STATE OF NORTH CAROLINA
DEPARTMENT OF TRANSPORTATION

Addendum No. 1

Contract No.: DA00292

Replacement of Bridge #21 over Swamp on SR 1563 in Martin County

GENERAL DRAWING
 FOR BRIDGE ON SR 1563
 OVER SWAMP
 BETWEEN US 64 AND SR 1557
 27'-10" CLEAR ROADWAY - 90° SKEW

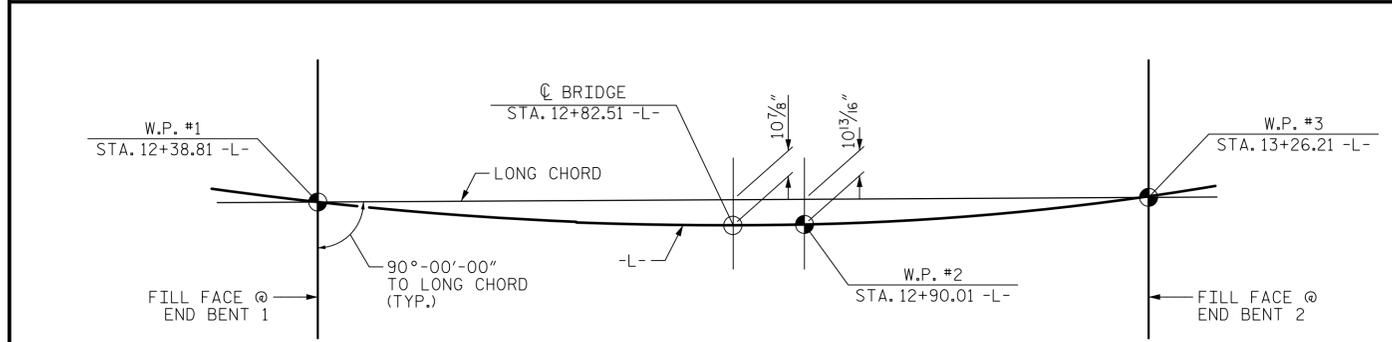
Plan Sheet Nos. S-2 & S-14 have been revised to remove the statement regarding the minimum length of galvanization on interior bent piles. Galvanization requirements will be as required by Notes to Contractor on Page 8 of the proposal. Please void existing Plan Sheet Nos. S-2 & S-14 and replace with revised Plans Sheet Nos. S-2 & S-14.

~~GALVANIZE THE TOP OF EACH INTERIOR BENT PILE A MINIMUM 40 FEET. GALVANIZE IN ACCORDANCE WITH SECTION 1076 OF THE STANDAR SPECIFICATIONS.~~

(SEE PROJECT SPECIAL PROVISIONS)

SUBSTRUCTURE
 BENT No. 1

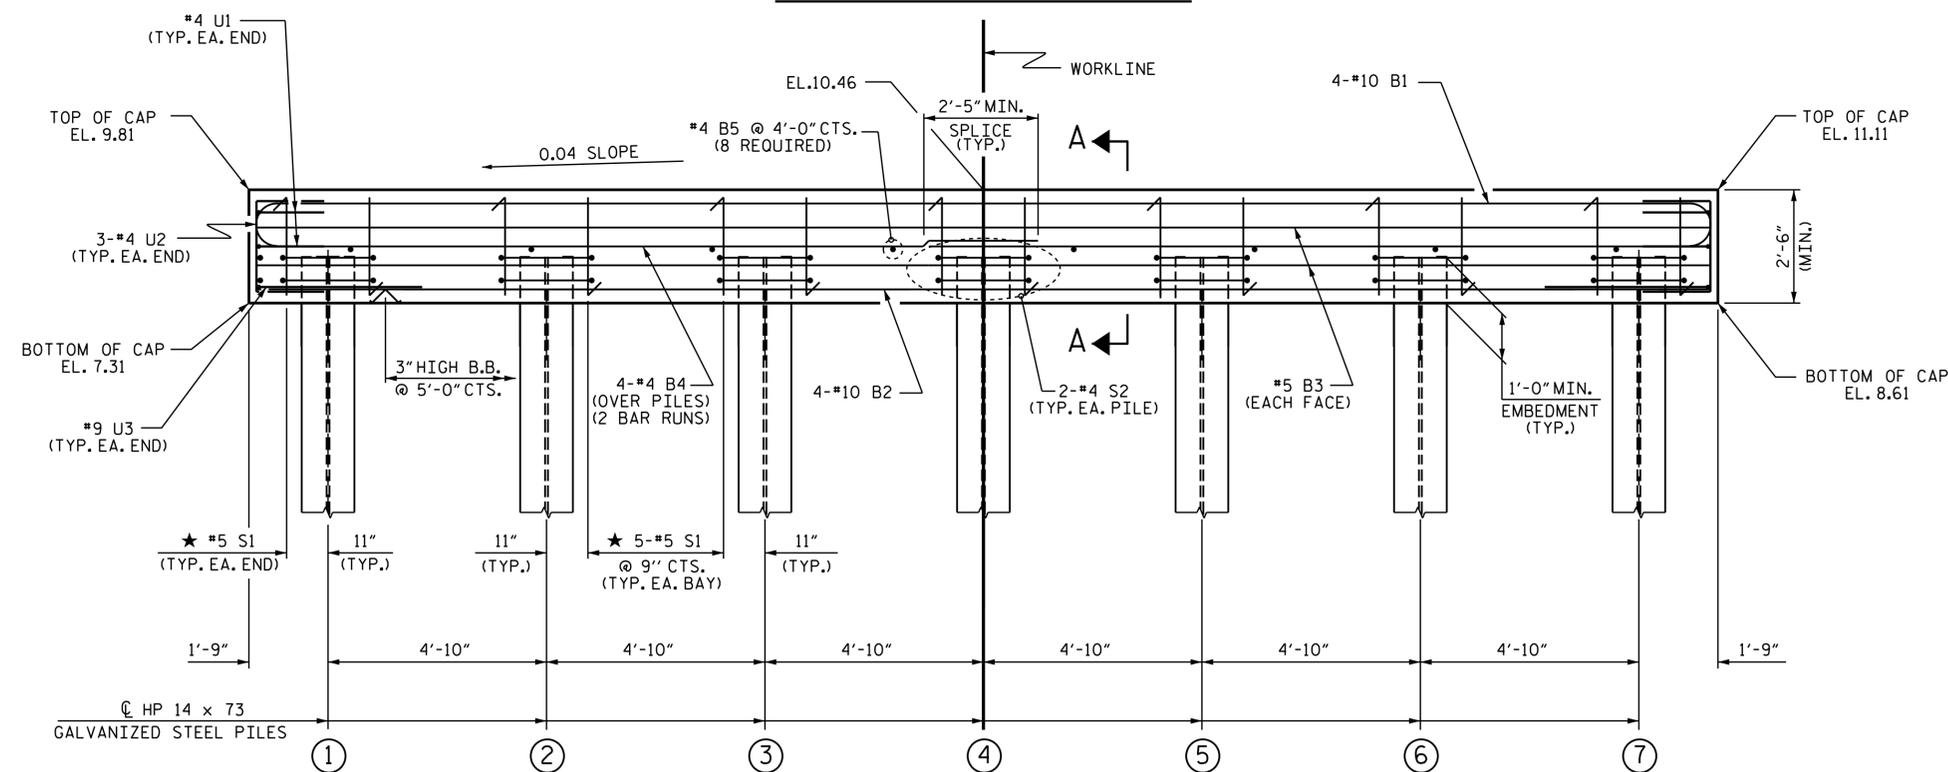
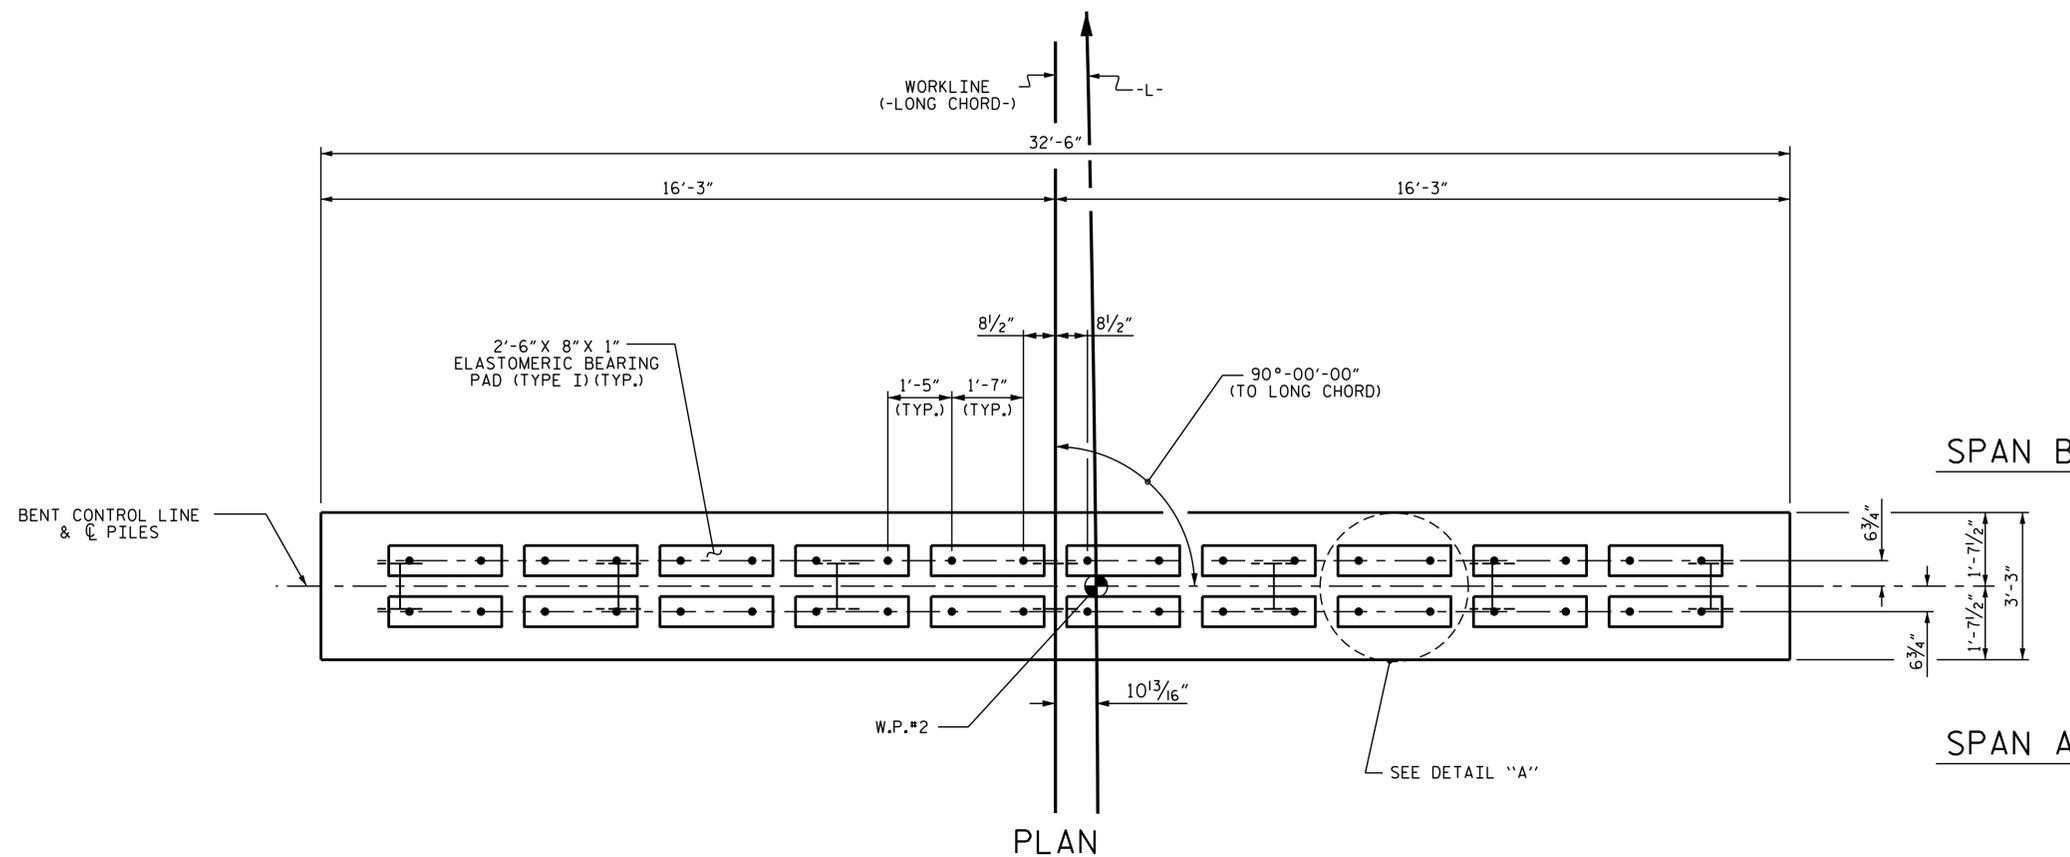
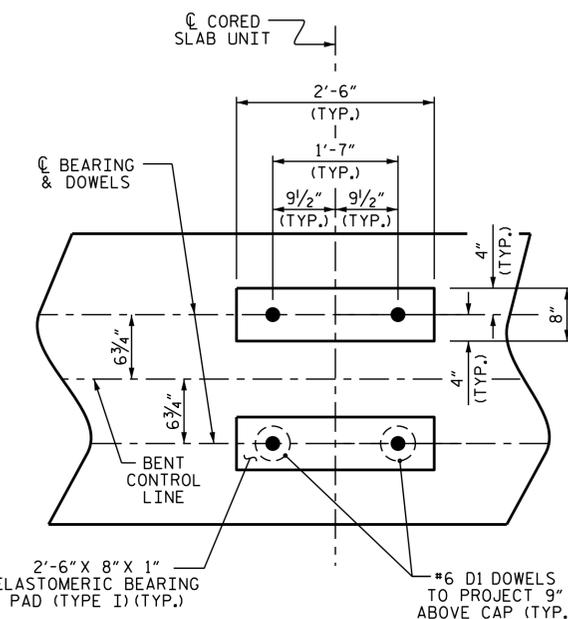
- STIRRUPS IN CAP MAY BE SHIFTED AS NECESSARY TO CLEAR DOWELS.
- ★ INVERT ALTERNATE STIRRUPS.
- ~~GALVANIZE THE TOP OF EACH INTERIOR BENT PILE - A MINIMUM OF 29.0 FEET. GALVANIZE IN ACCORDANCE WITH SECTION 1076 OF THE STANDARD SPECIFICATIONS.~~
- (SEE PROJECT SPECIAL PROVISIONS)
